11-IEP-1A

RE: Docket # 11-IEP-1A- Lead Commissioner's Draft Report – 2011 Integrated Energy Policy Report (IEPR)

Table 1
CEC demand forecast for SoCalGas vs. 2010 CGR demand forecast for SoCalGas

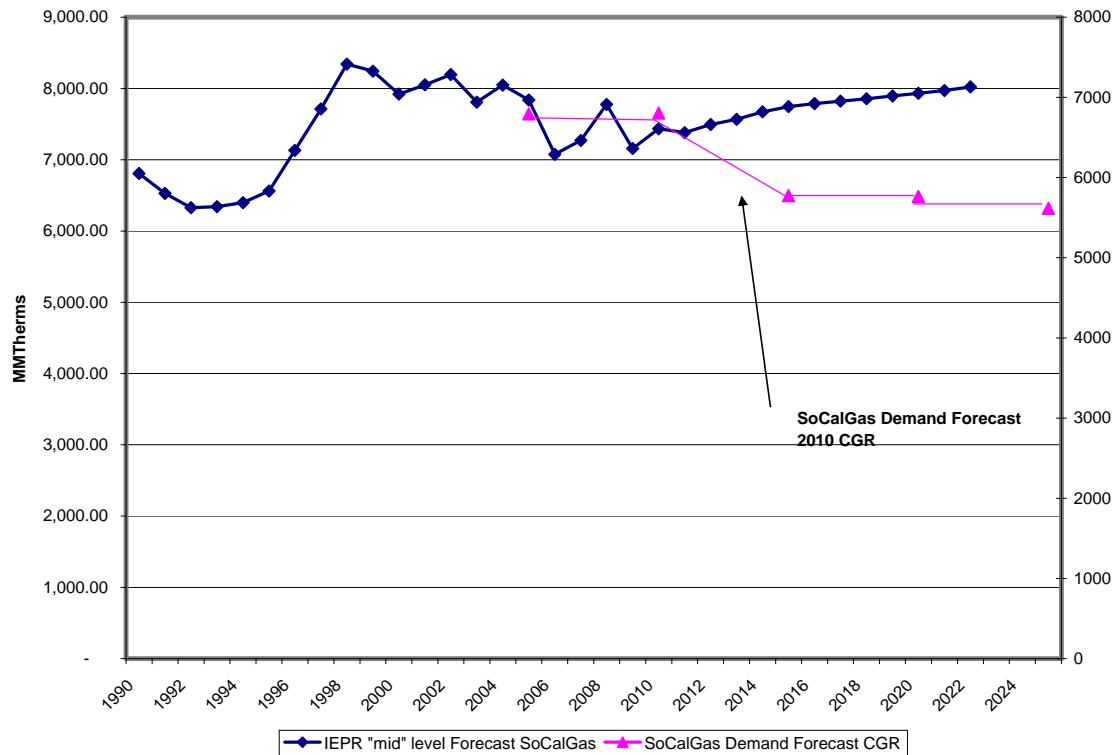
The CEC forecasts are significantly higher than the forecasts the California utilities prepared for the *2010 California Gas Report (CGR)*. The disparity between the forecasts is only 9% different in 2010 but the gap widens to 38% by the year 2020. The reason for this is likely due to more optimistic economic and customer growth forecasts and the fact that the CGR incorporates out-of-model adjustments which include energy efficiency savings and the expected savings attributable to AMI. SoCalGas and SDG&E assume that energy efficiency programs will continue beyond the current three-year Energy Efficiency program cycle while the CEC assumes no savings beyond the currently approved energy efficiency program funding. We recommend that the CEC revise its forecast and recognize energy efficiency savings beyond the current program years.

Table 2

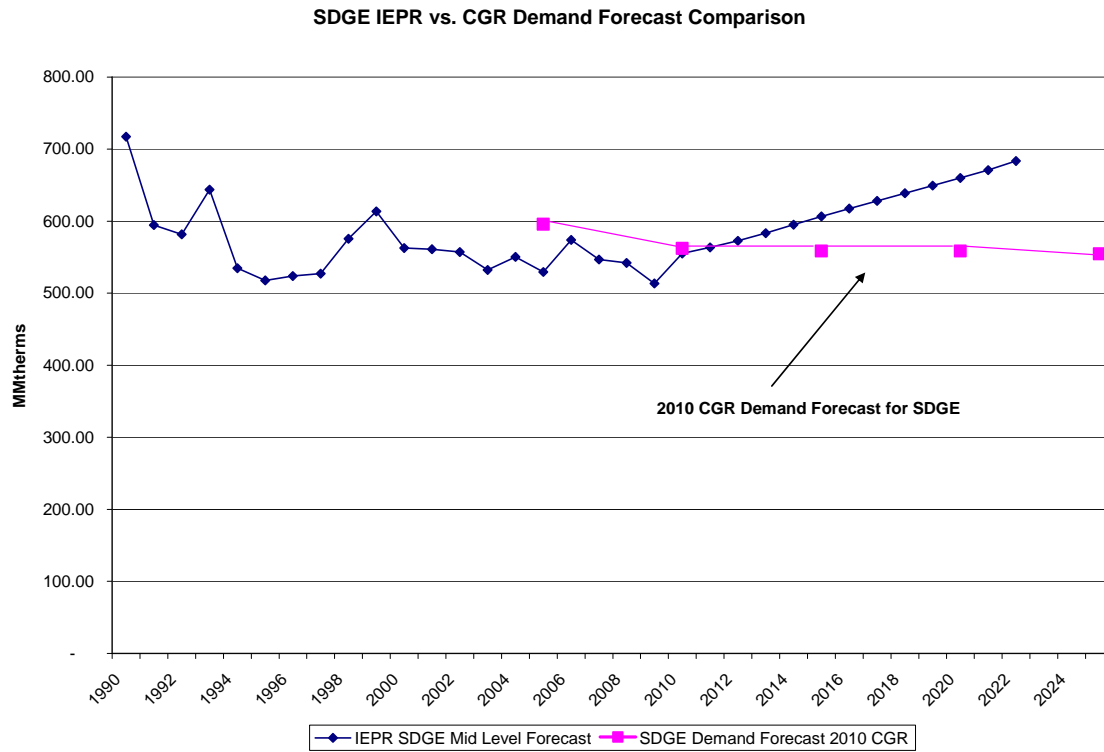
The disparity between the CEC’s forecast and the CGR forecast is only about 1% different in 2010. The disparity widens to 18% by the year 2020. The reason for the widening disparity is likely caused by the fact that SDG&E incorporates various out-of-model adjustments which include state-mandated, energy efficiency savings as well as the conservation anticipated due to advanced meters.
